NATIONAL WEATHER SERVICE

Engineering Handbook

MODIFICATION INDEX - AMOS III-70/73

AUTOMATIC OBSERVING EQUIPMENT MODIFICATION No.1
(For Electronics Technicians)

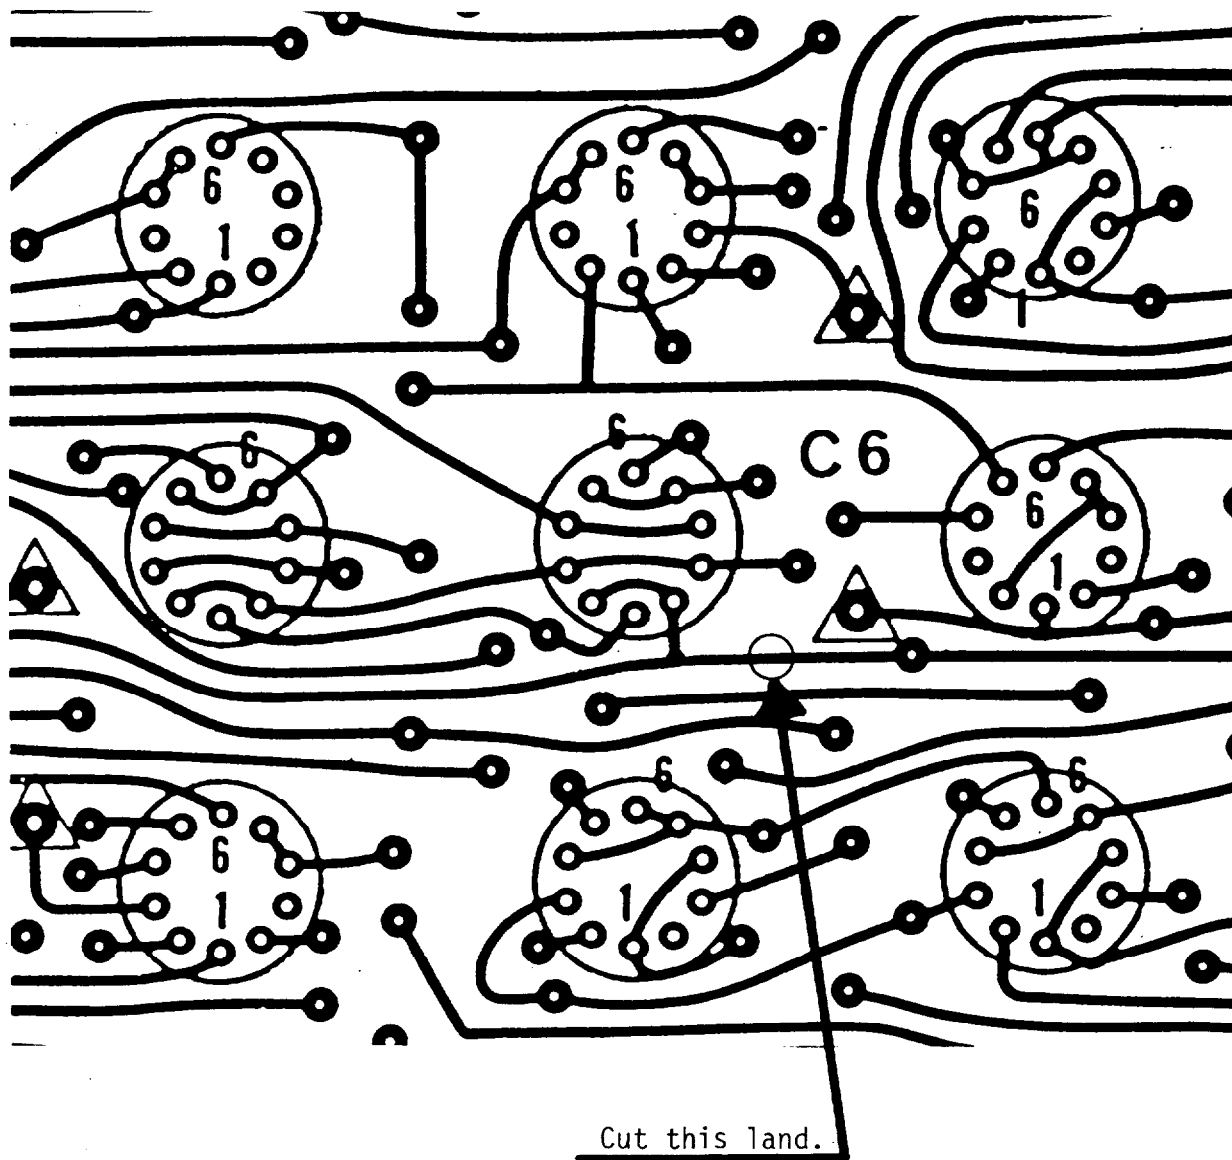
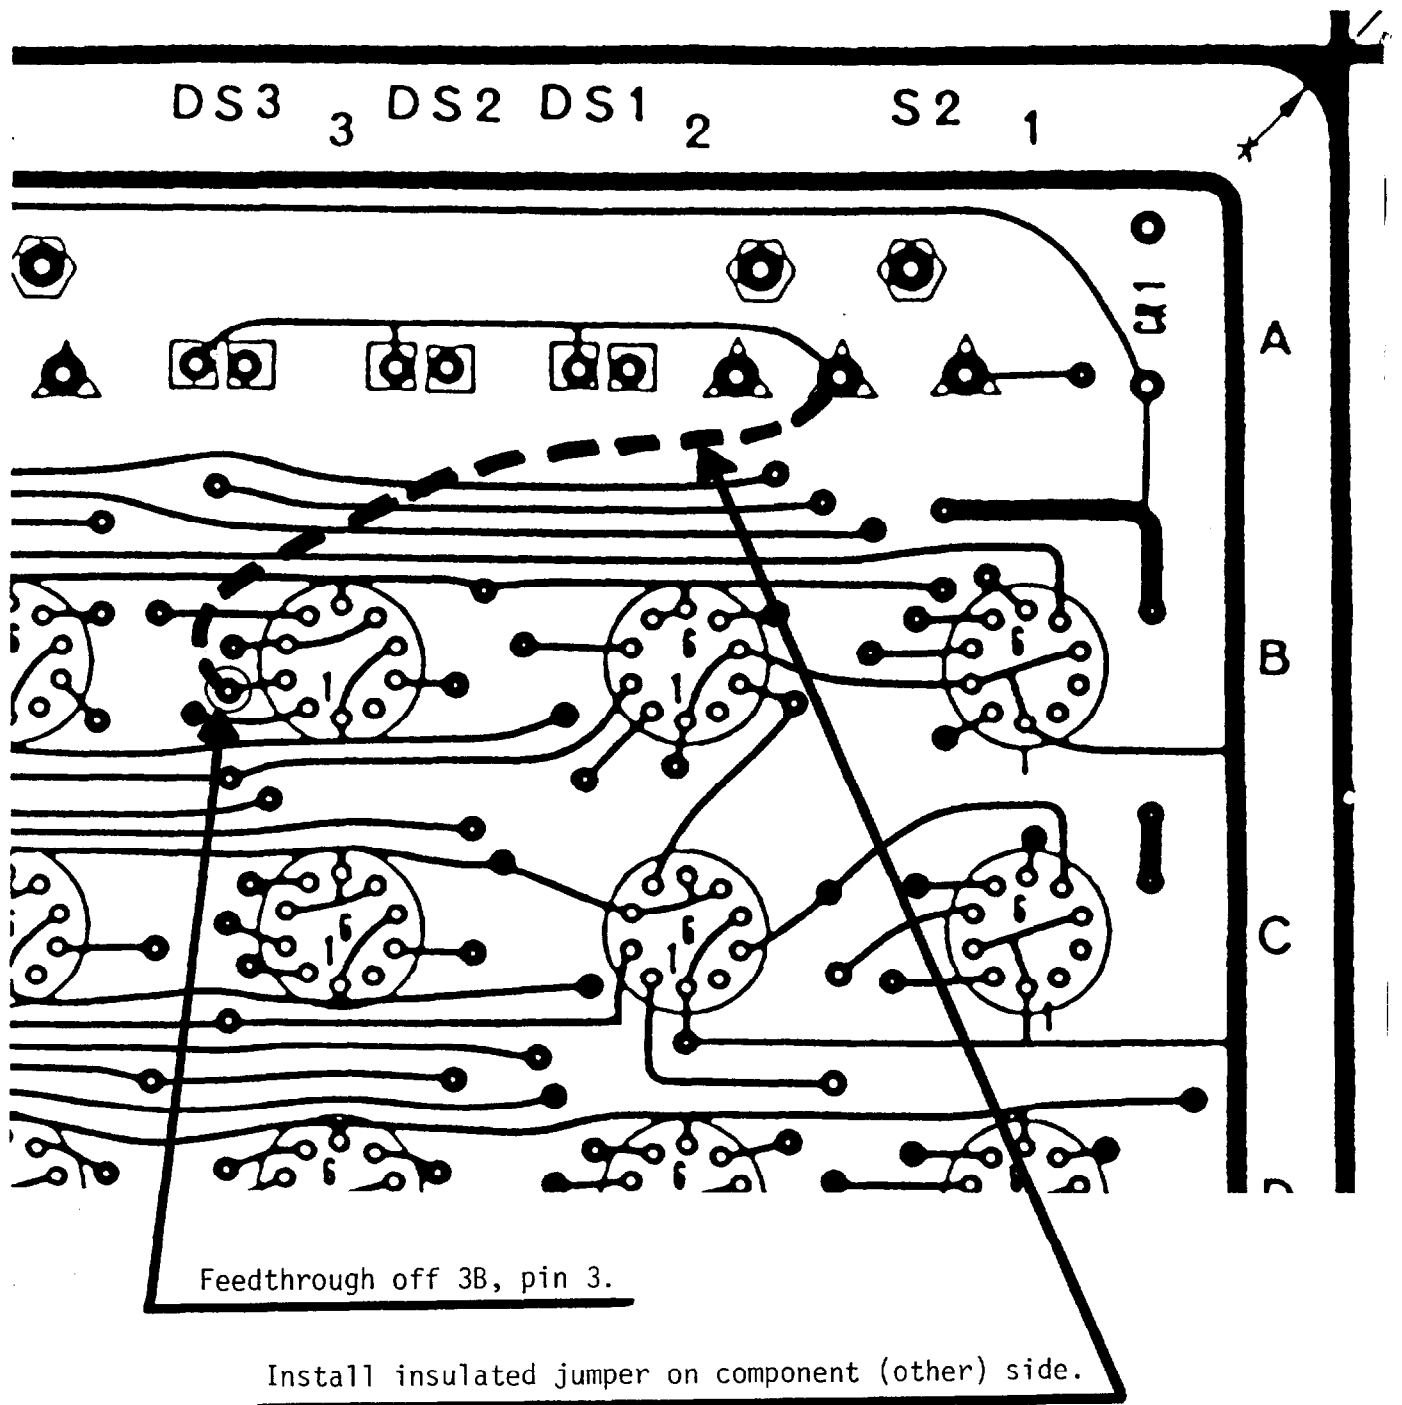
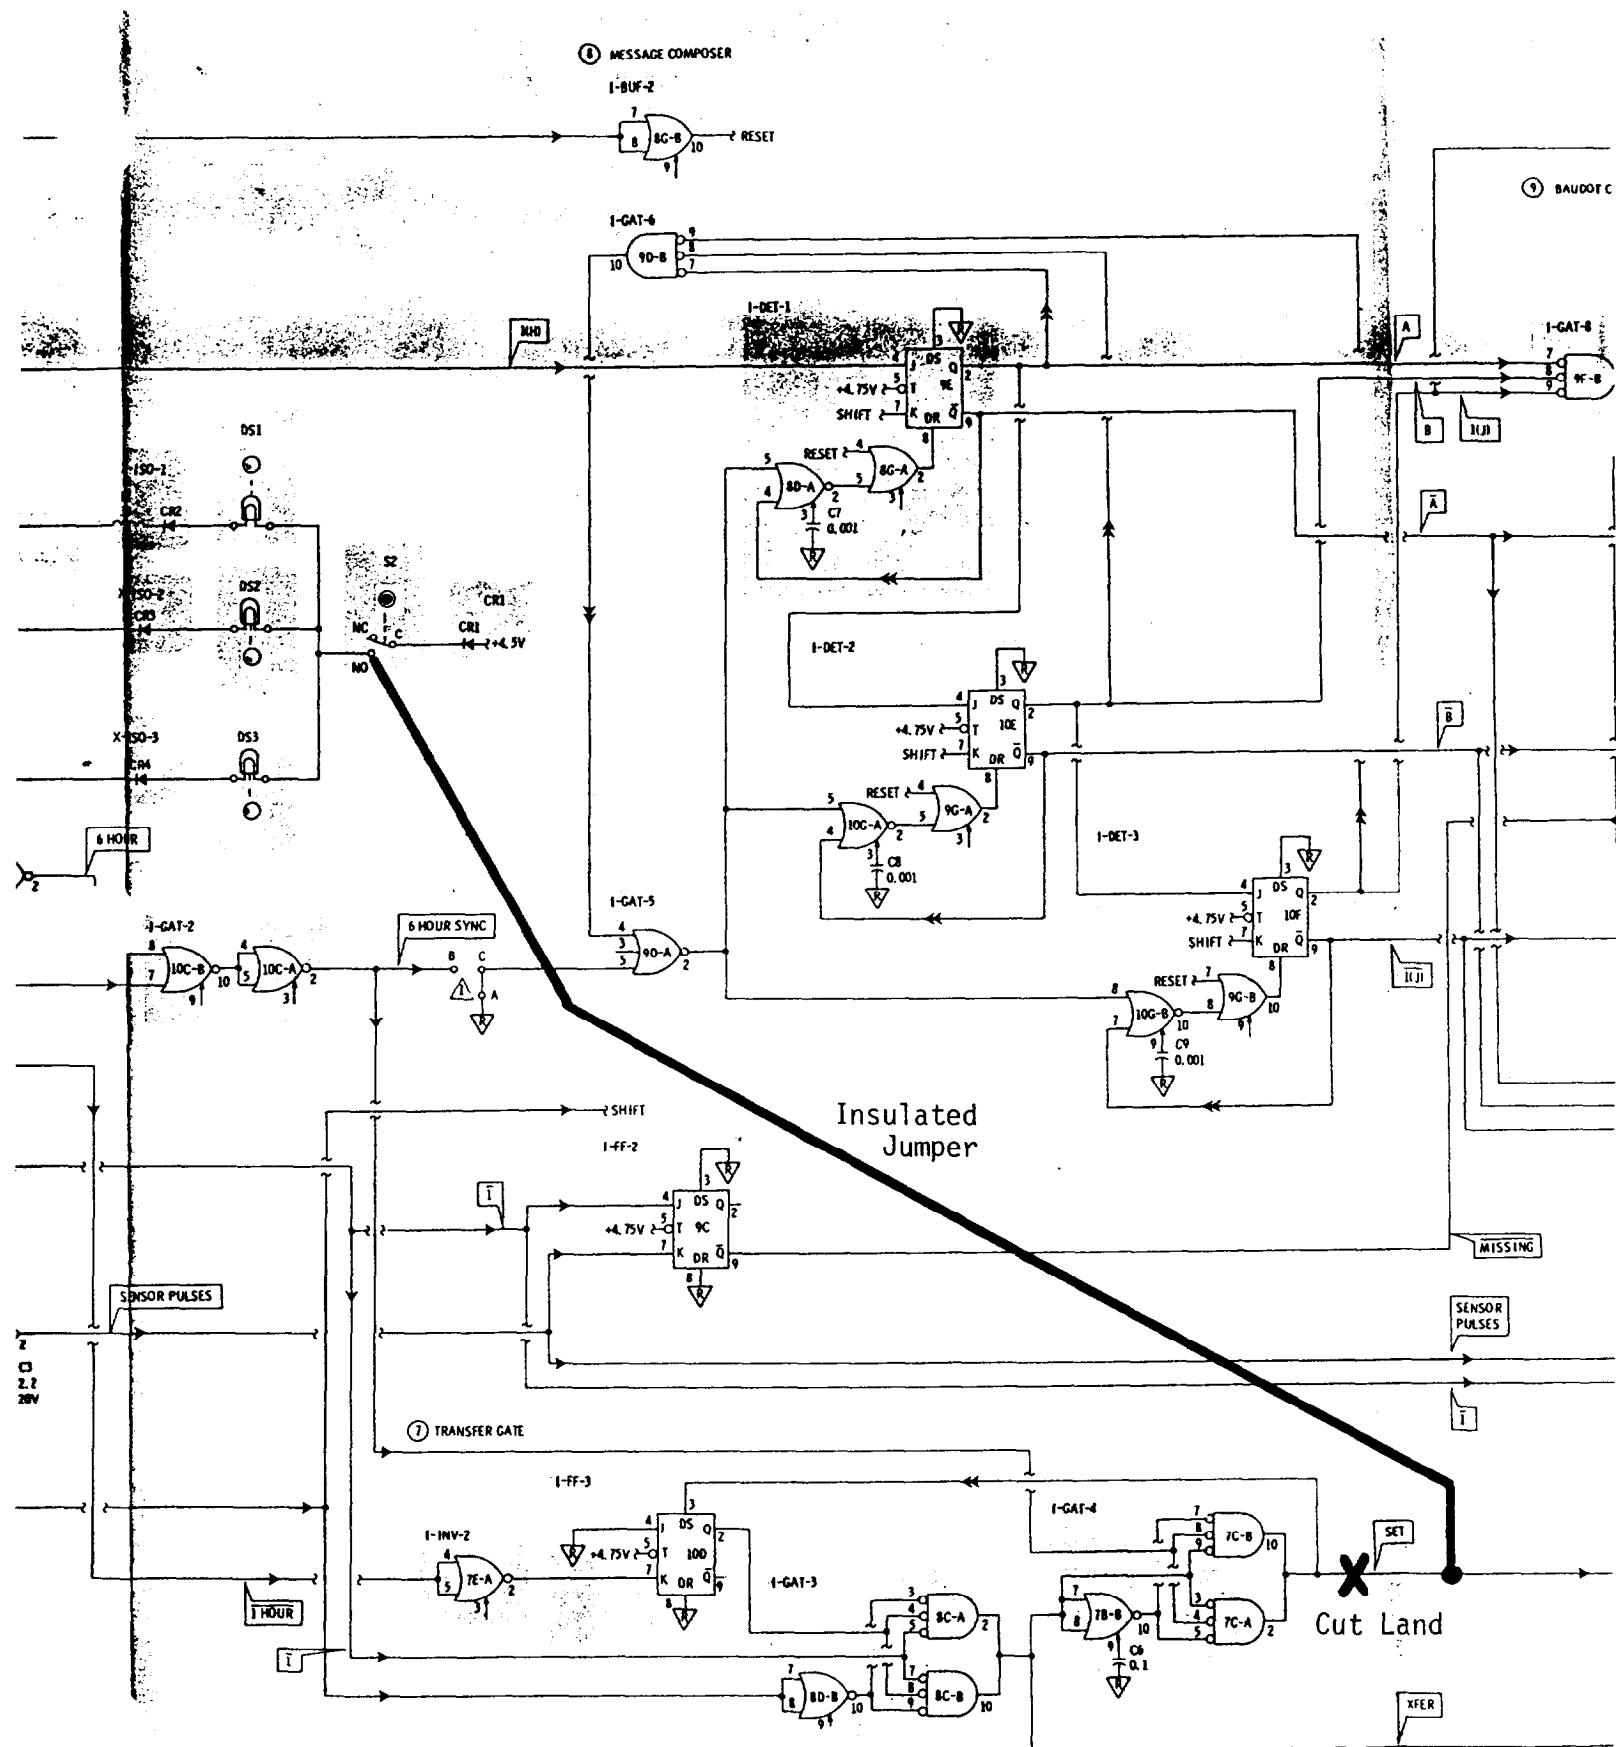
1. Power down AMOS and remove the Precipitation Accumulation Module (S007-1A2A14) to a suitable work area.
2. Using attached Figures 1, 2, and 4; locate the land emanating from integrated circuits 7C, pins 2 and 10; and 10D, pin 3. Using a very sharp knife, "Exacto" or equal, remove a small portion of the land identified in Figure 2. This will disconnect the "SET" output of the "TRANSFER GATE" from the "SET" input of the "PRECIPITATION COUNTER."

Place second copies of Figures 1 through 4 (attached) in front of p. 2-195 in AMOS manual.

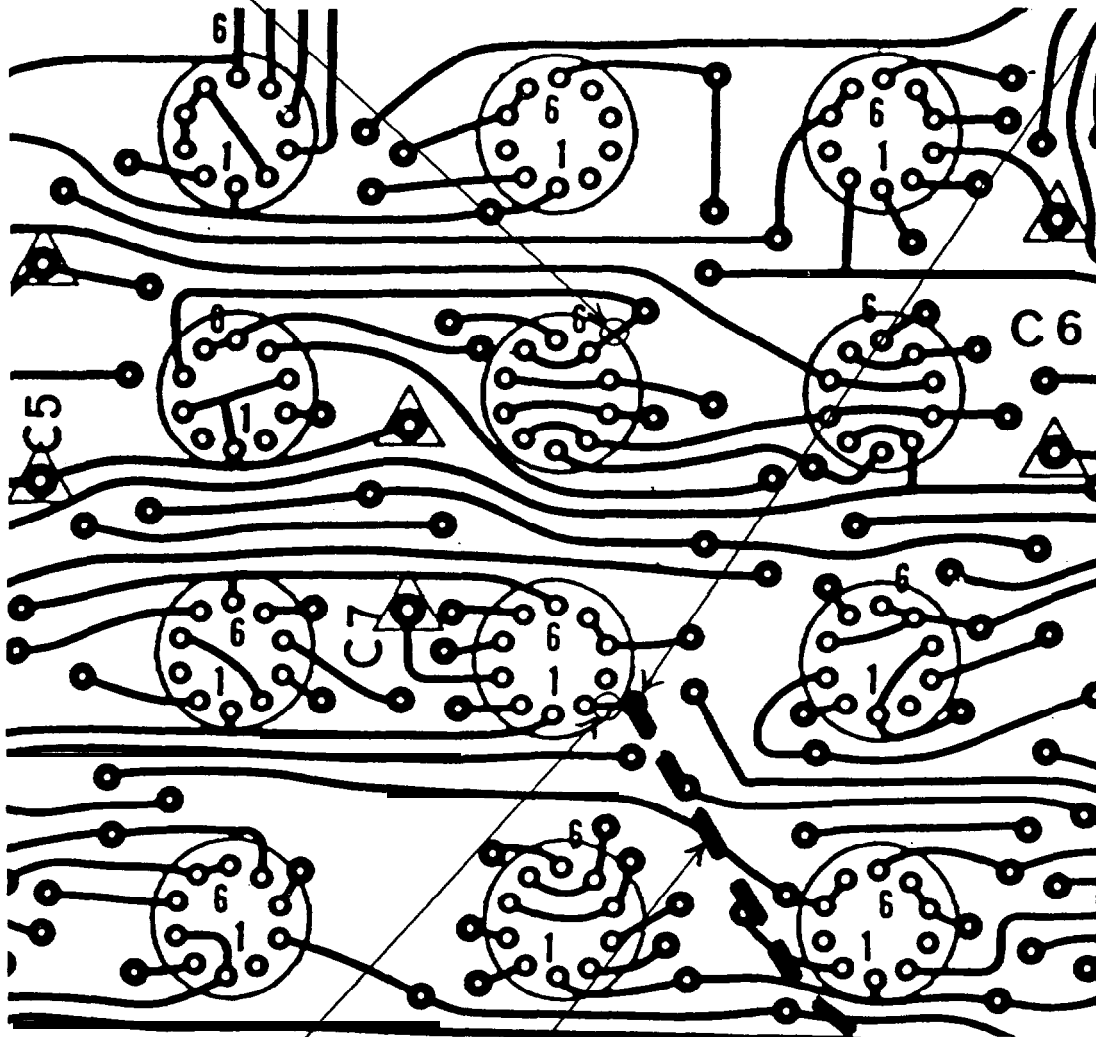
See Figure 2 for enlargement.

Insulated jumper to be installed
on component (other) side.

Cut land here.

Enl argement of Preci pi tation Accumulation Modul e, ci rcui t si de

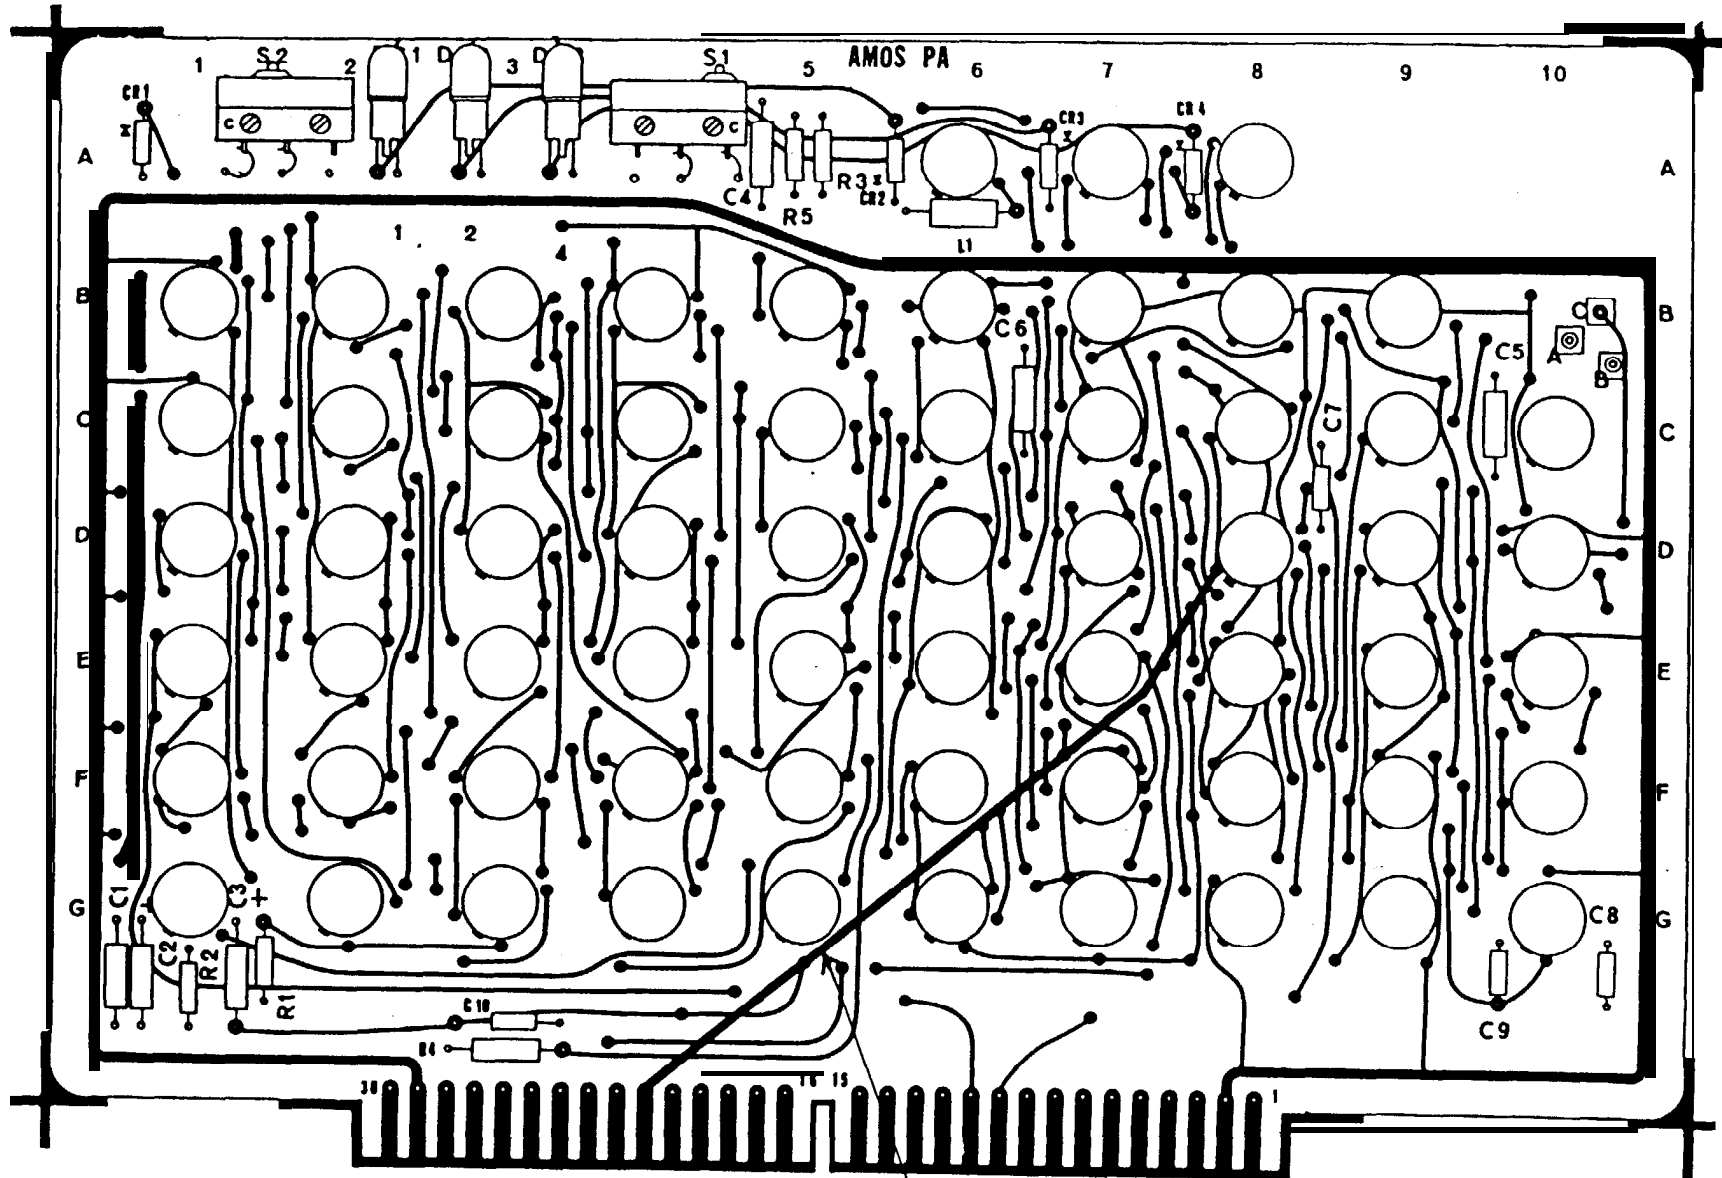
Feedthrough near 8D, pin 10.

Cut land here.

Insulated jumper to be installed
on component (other) side.
